TRAM D201

MODIFICATION FOR TRANSMIT ON MANUAL TUNER

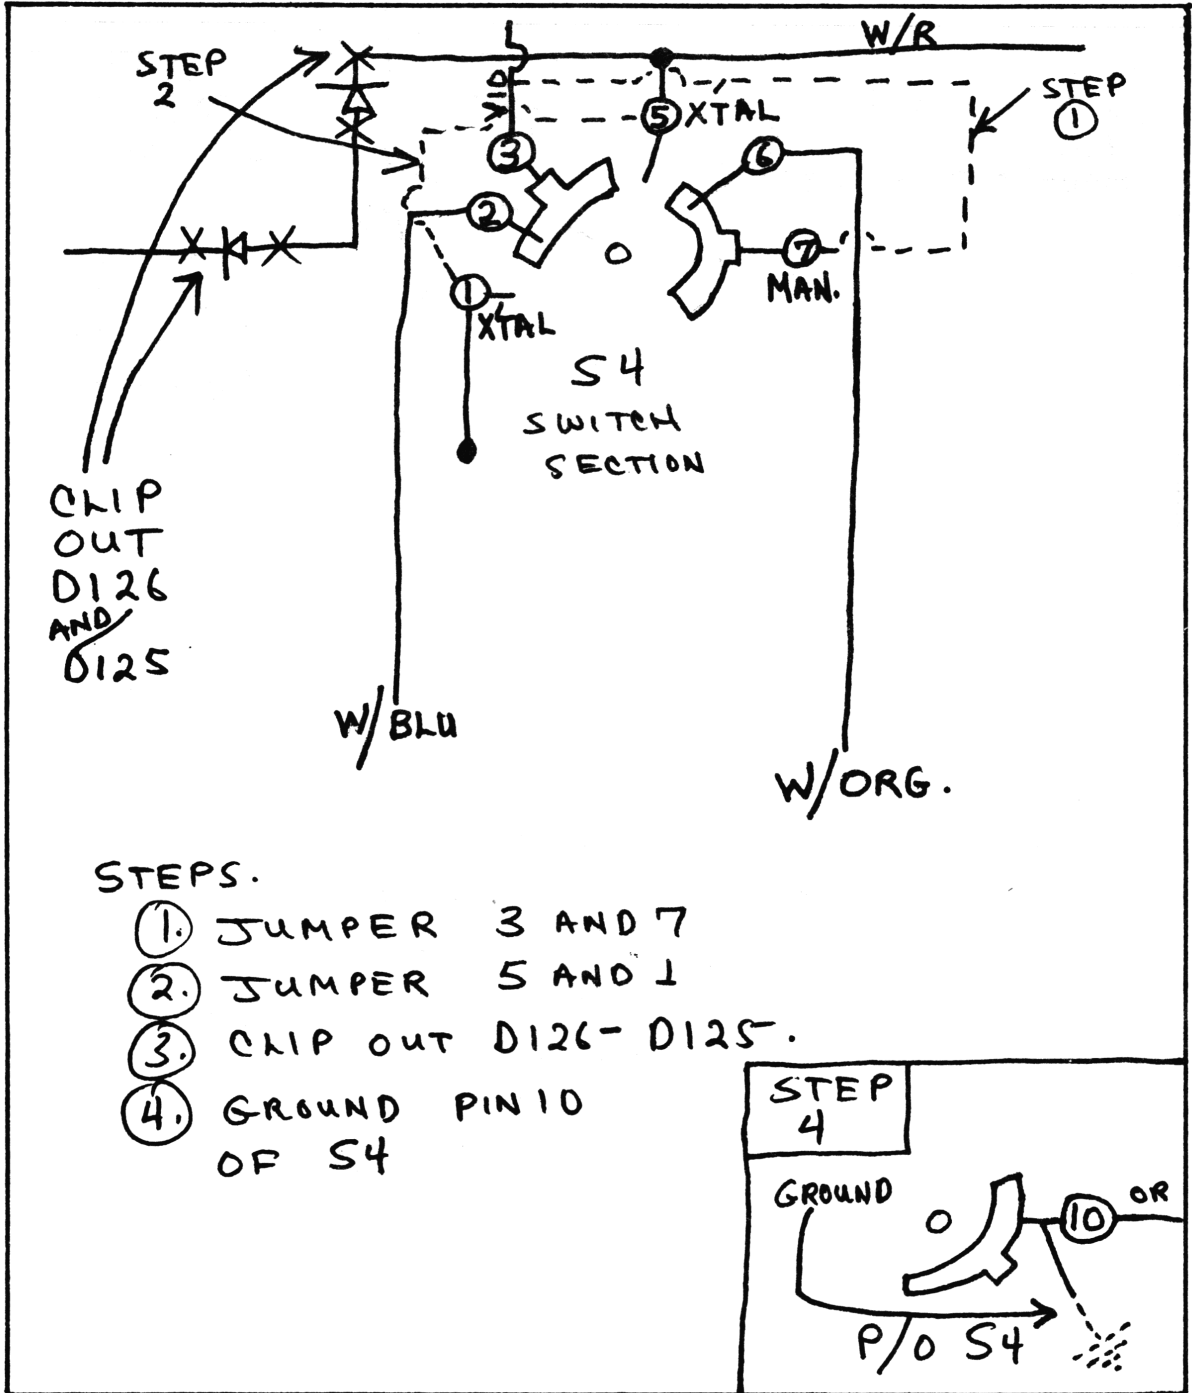
STEPS.

- ① JUMPER 3 AND 7
- ② JUMPER 5 AND 1
- ③ CLIP OUT D126 - D125.
- ④ GROUND PIN 10 OF S4
